# Intel® Mobile Celeron™ Processor Specification Update

Release Date: April 1999

Order Number: 244444-003

Figure 1. An Example of Microcontroller Driven Thermal Management

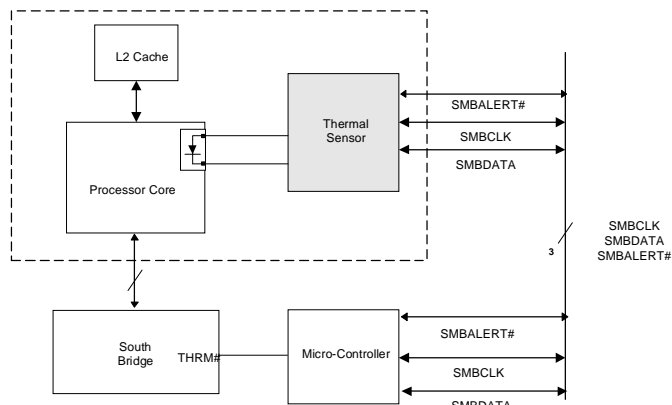
## H29. Thermal Sensor May Assert SMBALERT# Incorrectly

**PROBLEM:** The Intel Celeron Processor Mobile Module has a thermal sensor that monitors the processor core's temperature. Please note that desktop systems could have a similar thermal device. The thermal sensor asserts SMBALERT# if the processor temperature exceeds the temperature limits set in the Alarm Threshold Registers ( $T_{HIGH}$ ,  $T_{LOW}$ ). It also sets the corresponding Status Register bits to identify the cause of the interrupt. Figure 1 gives one example of the how the SMBALERT# signal could be used in a system.

Under the conditions described below, the thermal sensor incorrectly generates the SMBALERT# interrupt. *All* of the following conditions must be met to trigger a false interrupt:

**WORKAROUND:** Three different (mutually exclusive) workarounds are possible:

1. Before servicing an interrupt from the thermal sensor, read and compare the processor thermal reading with the threshold limits ( $T_{HIGH}$  or  $T_{LOW}$ ). Figures 2 and 3 provide basic flowcharts for the implementation of this workaround in an interrupt driven system.
2. If the firmware implemented polls the Status Register only, then before taking any action, re-read the temperature register and do a comparison with the alarm threshold limits ( $T_{HIGH}$  or  $T_{LOW}$ ) to determine if the value is actually still within the temperature window.
3. Use a temperature polling scheme to monitor the processor temperature.
